RE: Hope Christian School – Elementary
6721 Palomas Ave. NE
Grading and Drainage Plan
Engineer's Stamp Date: 02/21/19
Hydrology File: D18D009A

Based upon the information provided in your submittal received 02/22/2019, the Conceptual Grading Plan and Drainage Report **is not** approved for action by the DRB for Site Plan for Building Permit. The following comments need to be addressed for approval of the above referenced project:

CD-2

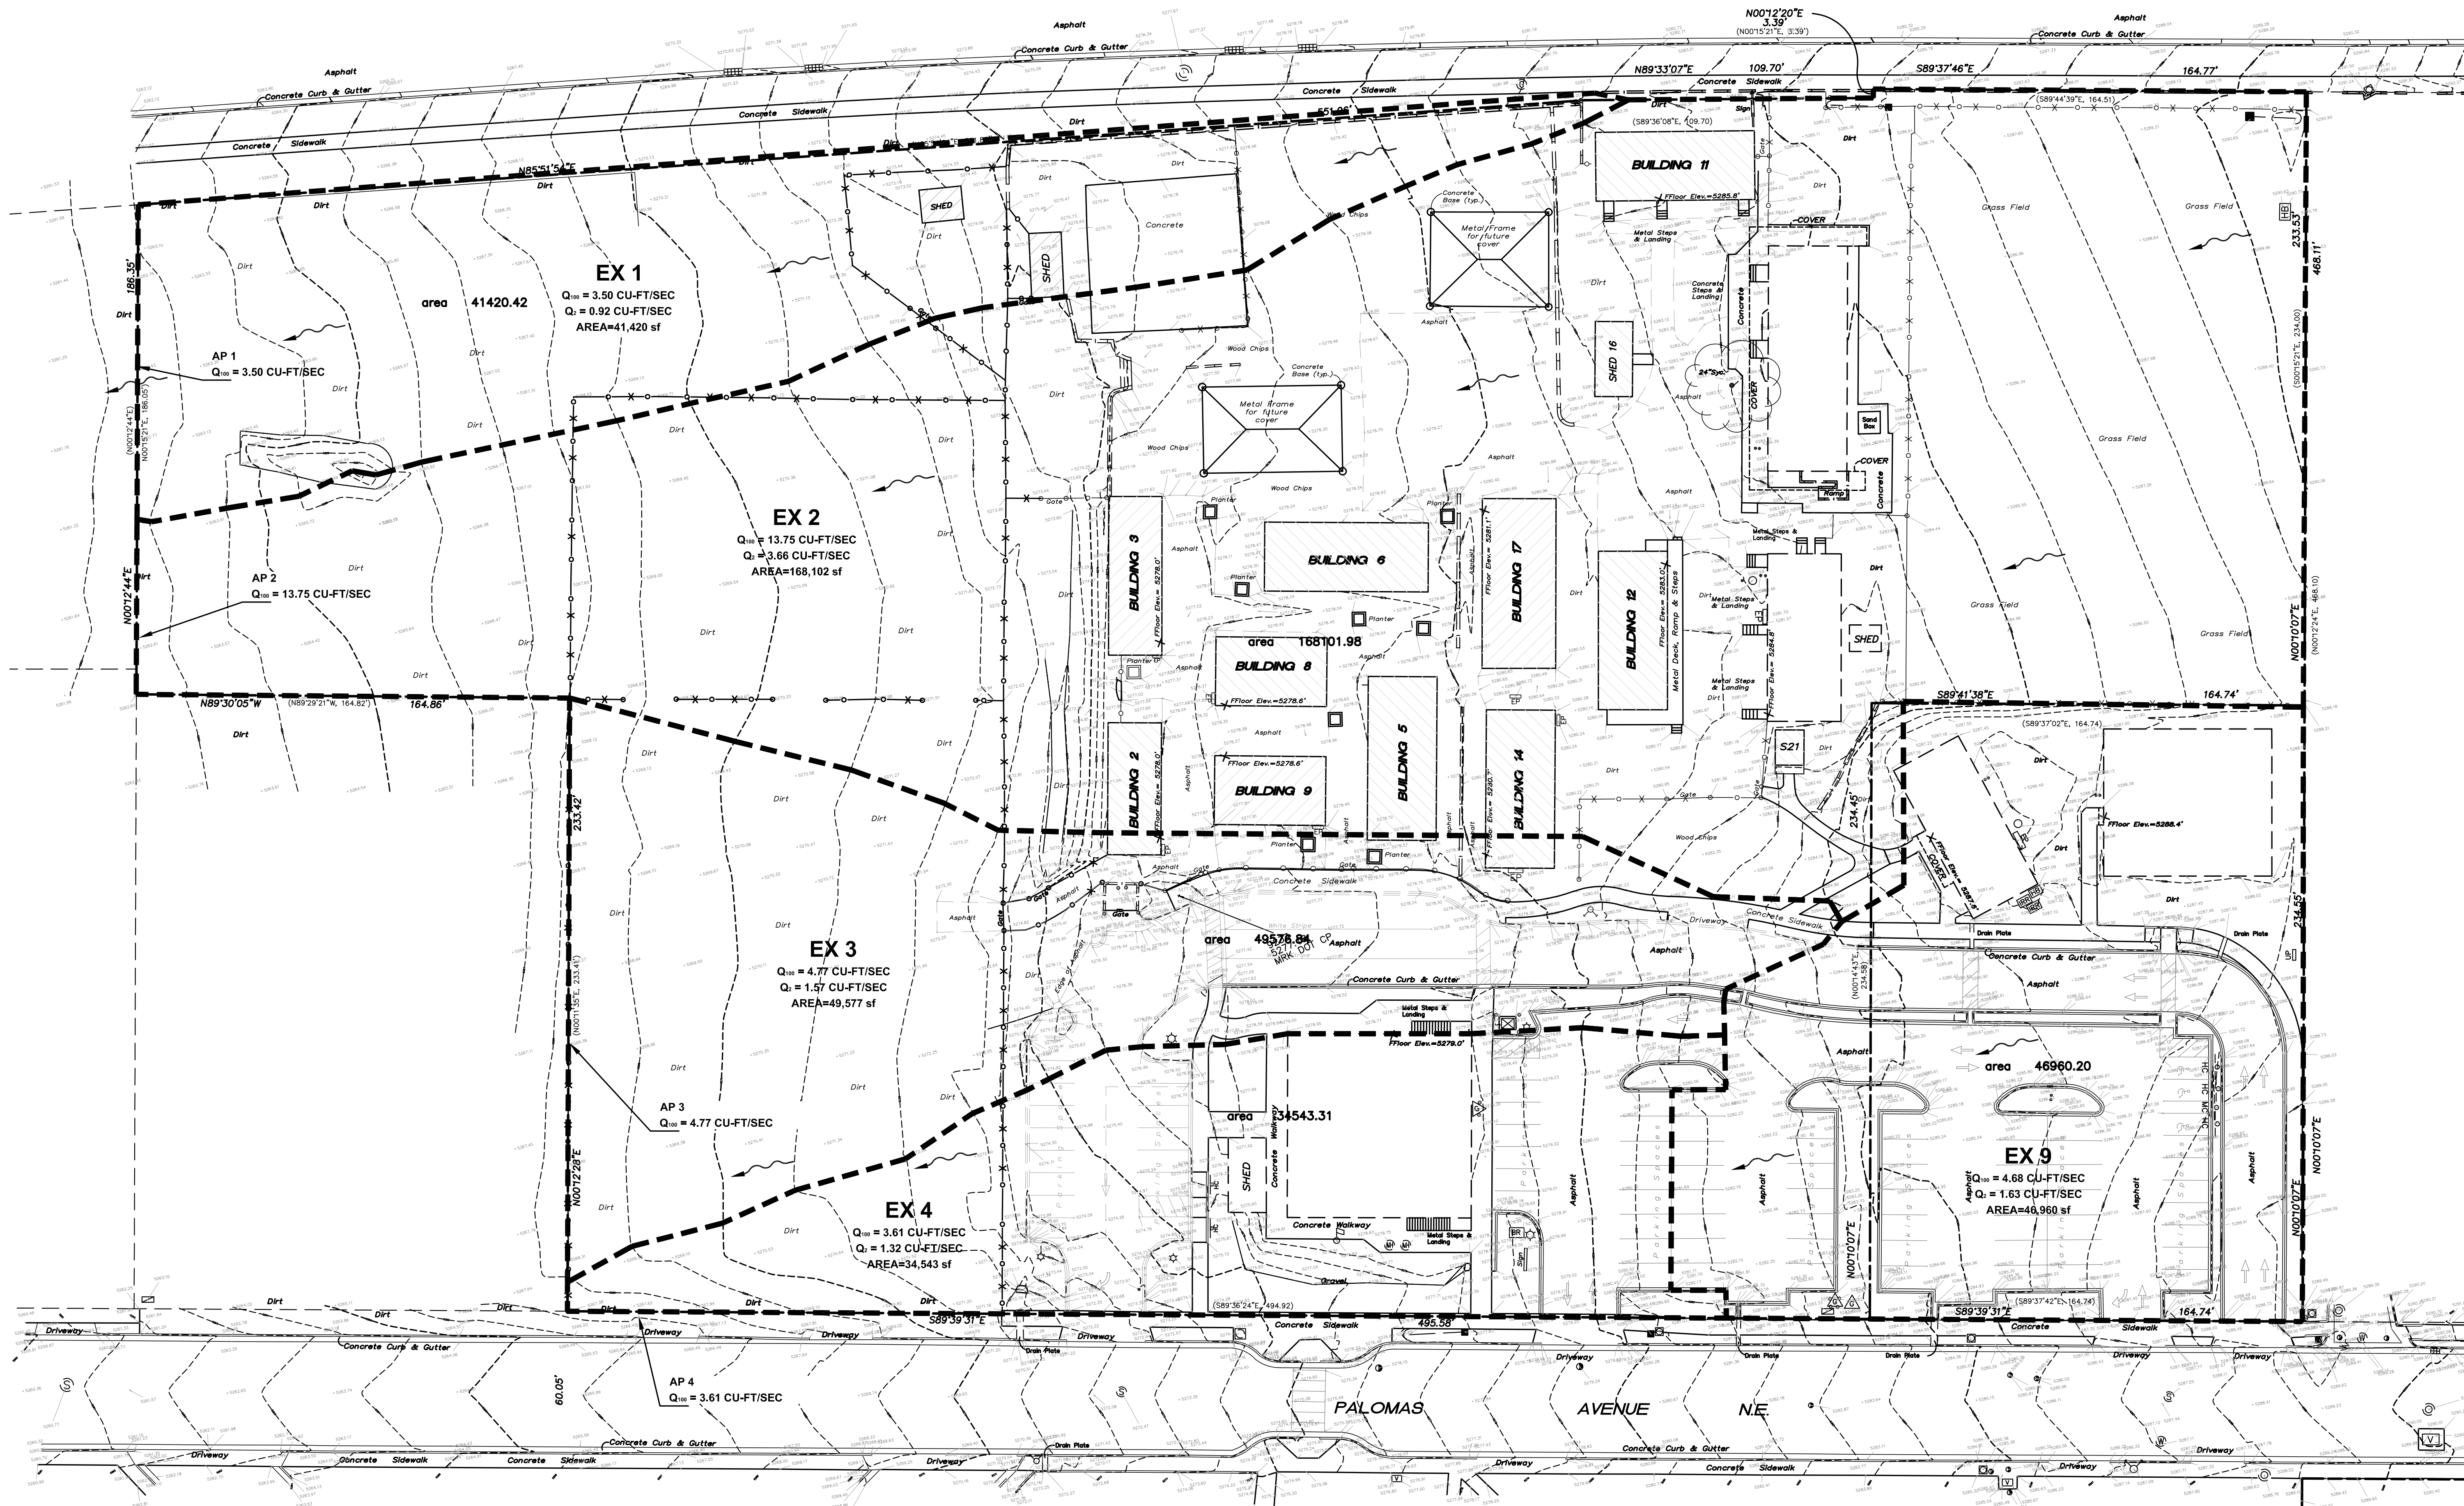
8. Sheet CD-2. Please fix Drainage Areas EX3 and EX4 to show the existing paving draining through the existing sidewalk culvert in Drainage Area EX4.
9. Sheet C-203. Please add some flowline information within the proposed parking lot.

1 SITE DRAINAGE PLAN - PROPOSED CONDITIONS
1" = 30'-0"

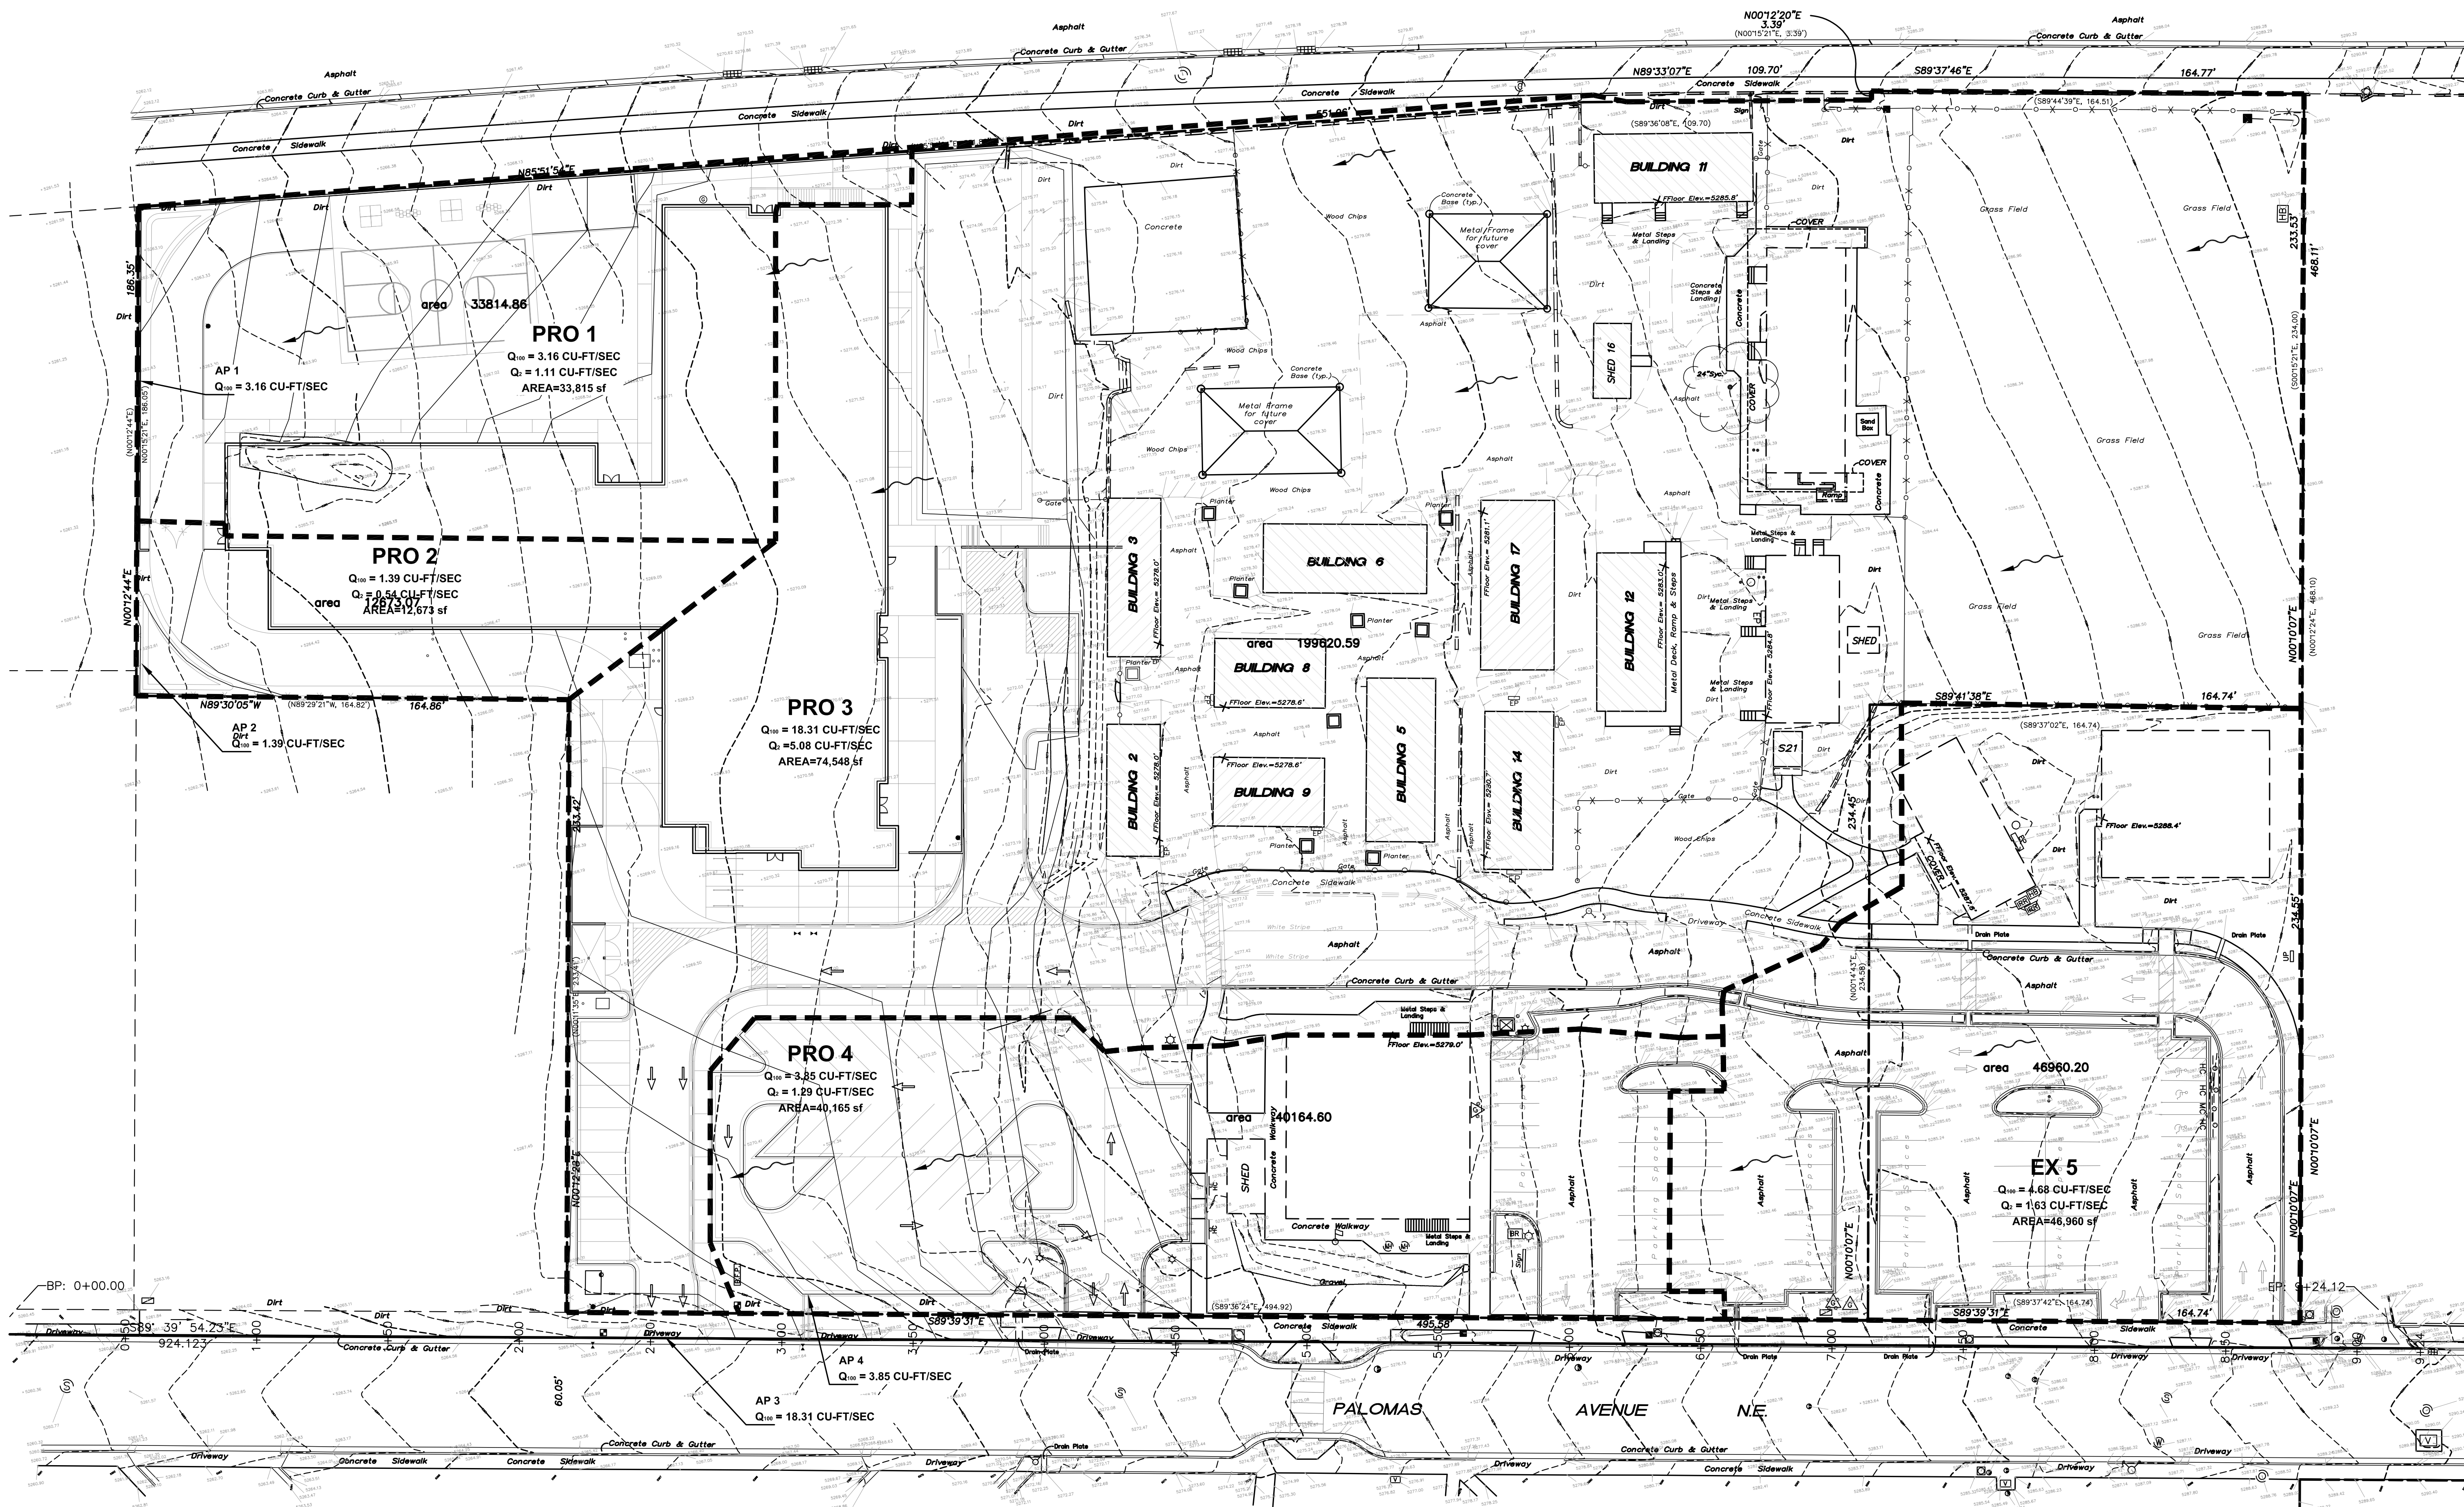
1. Sheet CD-1. Please provide the FIRM Map and flood plain note with effective date.
2. Sheet CD-1. Please provide the legal description of the property.
3. Sheet CD-1. Please add a note under the Drainage Management Plan stating, "The Western adjacent property has accepted up to 6.08 cfs of runoff from the Hope Christian School property."
4. Please add the word "Conceptual" to all the sheets title and also add a note stating "Not for Construction" to all sheets.
5. Please scale back (make lighter) all the existing information (contours, bldgs., & paving). Also bring forward (make bolder) all proposed information (contours, bldgs., SWQ ponds, & paving).
6. Please insure that only the proposed construction is required to provide the SWQ requirement.
7. Please label all the SWQ ponds with the proposed volume.
